# UNITED STATES PATENT AND TRADEMARK OFFICE

APPLICATION NO.	FILING DATE	FIRST NAMED INVENTOR	ATTORNEY DOCKET NO.	CONFIRMATION NO.
10/666,462	09/19/2003	Brent Stone	42P16890	8351

**Office Action Summary**

## **DETAILED ACTION**

FIG. 4

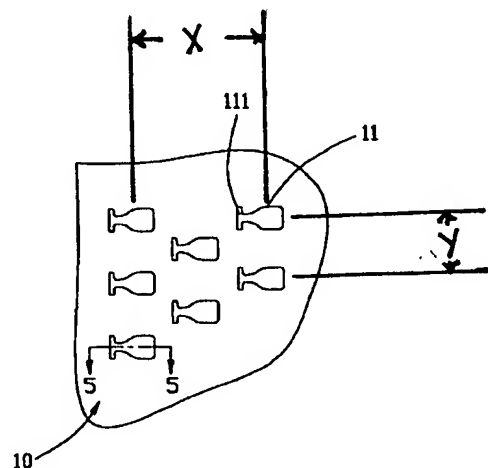
Lin discloses an apparatus comprising a printed circuit board (PCB) 5 having a plurality of contact pads 51; a connector 1 mounted on the PCB 5; and an integrated circuit (IC) package 6 for insertion into the connector 1, having a plurality of input/output (I/O) lands 61. Figure 4 shows the connector 1 with a plurality of contact opening 11 including a vertical pitch having a first uniform distance and a horizontal pitch having a second uniform distance. Figures 7 and 8 shown pitch distances of the I/O lands 61 of the IC package 6 and the contact pads 51 of the PCB 5 match with the contact opening 11 of the connector 1. Although Lin does not states the connector 1 being a zero insertion force (ZIP) connector, Figure 1 clearly shows that the connector 1 of Lin is a ZIP connector because the IC package 6 is simply dropped into the connector 1.
